Service Bulletin

Bulletin No.: 21-NA-014

Subject: Intermittent Malfunction Indicator Lamp (MIL) Illuminated - DTC P146F Set

5710159

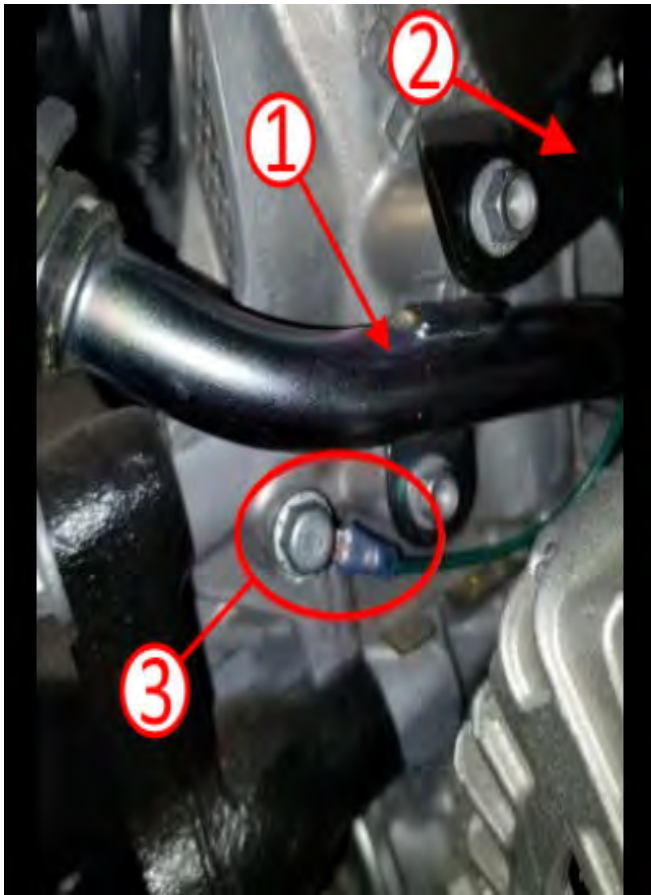
2. Measure the resistance drop from G58: Evaporative Emission Purge Pump terminal 2, to the negative terminal at the battery.
 - Resistance as high as a 2.3Ω was found on ckt 580 from terminal 2 of the G58 Emission Purge Pump to Battery negative post, (.11 mV drop.)
3. Cut the circuit 580 (BK/GN) approximately 2" back from the G58 Emission Purge Pump electrical connector.

4. Strip the insulation from the wire of the ground, crimp in eyelet connector.
5. Install the Low Reference circuit onto its own ground, to a threaded hole just below the coolant pipe (1) and Emission Purge Pump Bracket (2) directly to the engine block (3).
6. Recheck the resistance drop.
 - The resistance from G58 Evaporative Emission Purge Pump terminal 2 to battery negative, now had .4Ω of resistance (.02mV).
